1. Project Name: Kihei Beach SPP
2. Date of Inspection: September 17, 2009
3. Inspection Personnel:

CONTINUING ELIGIBILITY INSPECTION (CEI) REPORT
FOR HURRICANE & SHORE PROTECTION PROJECTS
Honolulu Engineer District
CEPOH-EC-T

KIHEI BEACH, MAUI, HAWAII

Enclosure(s)
Site Plan

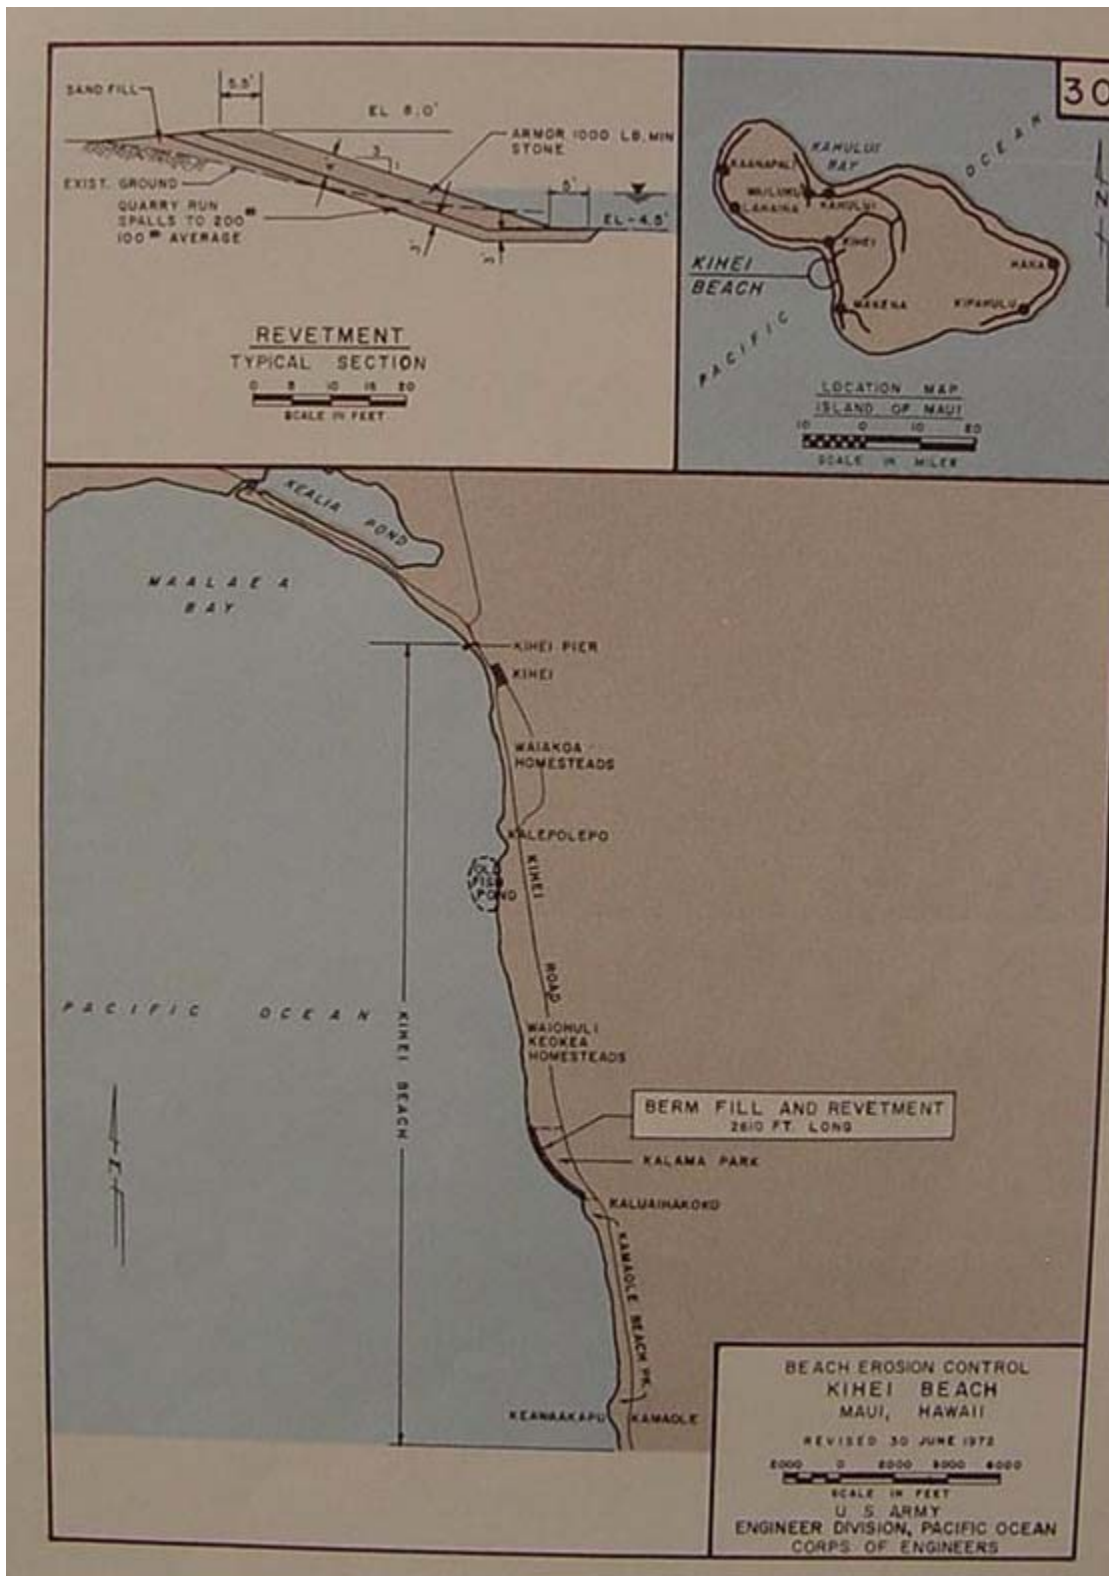
- a. Sta. 0+70 to Sta. 0+90, Remove vegetation from crest and sideslope.

b. Sta. 2+90, Fill material added to eroded area.

c. Sta. 3+00, 1st access walkway, repair cracks in sidewalk as needed.

d. Sta. 3+20, Monitor minor settling at hinge. No Change.

e. Sta. 3+48, Monitor the armor stone resting adjacent the toe. Minor change this year. No obvious voids.

f. Sta. 3+76, to Sta. 4+06, Monitor the area adjacent to cracked armor stone for settling.

g. Sta. 3+96, 1 ea. Displaced armor stone, void at toe. Monitor Sideslope.

- h. Sta. 5+00 to Sta. 8+00, Remove Kiawe trees (including stumps) impacting the revetment structure.

- i. Sta. 8+73, 2nd Walkway, CRM, repaired.

j. Sta. 8+73, 2nd, access walkway, repair cracks in sidewalk as needed.

k. Sta. 10+00, Monitor settling on sideslope, no change this year.

- l. Sta. 11+00 Add fill material to eroded area.

- m. Sta. 12+88, Monitor sideslope settling. No change since FY03.

- n. Sta. 12+92, Monitor the depressed area on sideslope. No change since FY03.

- o. Sta. 13+29, Remove vegetation from revetment.

p. Sta. 13+80, No Change since FY04. Remove the vegetation from revetment .

q. Sta. 23+00 to Sta. 20+00, Overview, backfill eroded area filled sidewalk new this inspection.

- r. Sta. 23+11, 3rd Access walkway, add fill material to eroded area.

- s. Remove juvenile vegetation from revetment.

t. Sta. 24+50, Remove tree from revetment.

u. Sta. 23+50, Access walkway with recent repairs.

- v. Sta. 23+75, Monitor the sideslope settling on the southside of the culvert and broken culvert rails removed.
